**Project Addresses:** 306 N Brooks Street

**Application Type:** Demolition Permit, Zoning Map Amendment, Conditional Uses, and Certified Survey Map Referral

**Prepared By:** Chris Wells, Planning Division  
Report includes comments from other City agencies, as noted

**Image 1: Building Heights Surrounding the Subject Site. (Source: Vierbicher Associates)**

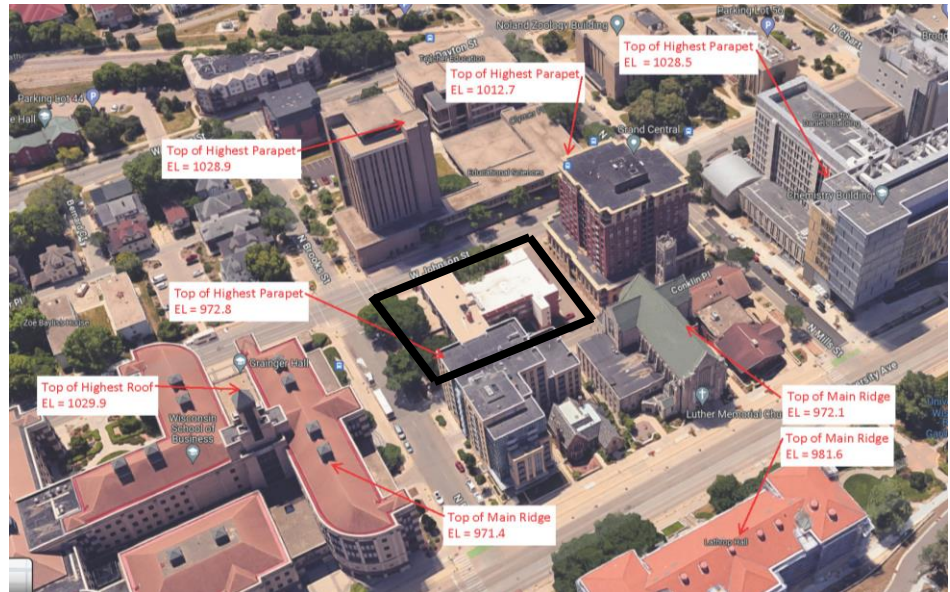
This means that there are three buildings located in the surrounding block (four if you count the Grainger Hall spire) that rise up to at least the 1,012-foot mark (or within roughly 20 feet of the proposed building), two of which rise up to less than five feet of the proposed building. Furthermore, the proposed building’s mass and stepbacks closely resembles that of the adjacent Grand Central apartment building to the west which also has a roughly five-story base before stepping back on all sides.
